AERONAUTICAL CHARTING MEETING
Charting Group
Meeting 21-02 – October 26 - 28, 2021

RECOMMENDATION DOCUMENT

FAA Control #21-02-363

Subject: Simplification of Airport Sketch Final Bearing

Final approach track bearing and distance from OM/fix to the threshold/landing area (335° 2.4 NM from DIXIE)

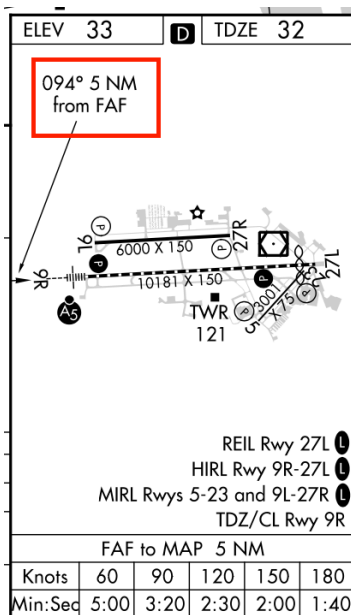
The airport sketch provides pilots a quick visual reference as to how the final approach course intersects the airport's runway configuration. Depending on the type of approach and procedure design, however, the information presented to pilots is inconsistent. For example, the airport sketch may contain (all at KMLB):

These distinctions make no difference. This issue was briefed in 2012 at the ACF as agenda item 12-02-257. As discussed then, the information beyond the final approach bearing is superfluous and is already contained in other parts of the chart. Despite widespread agreement to simplify the sketch to only contain bearing information, at the time DoD prevented its adoption. NGA, as the authority for DoD charting, disagrees with that earlier objection. In consultation with DoD Service representatives, we would now like to implement this proposal.

Revise IAC 4 paragraph 3.4.76 to the following:

The final approach **course** on all IAPs except ILS CAT II, ILS CAT II & III, ILS SA CAT I, ILS SA CAT II, and ILS SA CAT I & II, shall be shown by a 2 weight (.006") line, with arrowhead. This line shall extend from the neatline toward but not touching the designated threshold/landing area or NAVAID when located on the airport. Placement shall be such as to avoid overprinting. **The bearing value shall be shown located near or leadered to the arrowed line, e.g., 168°.**
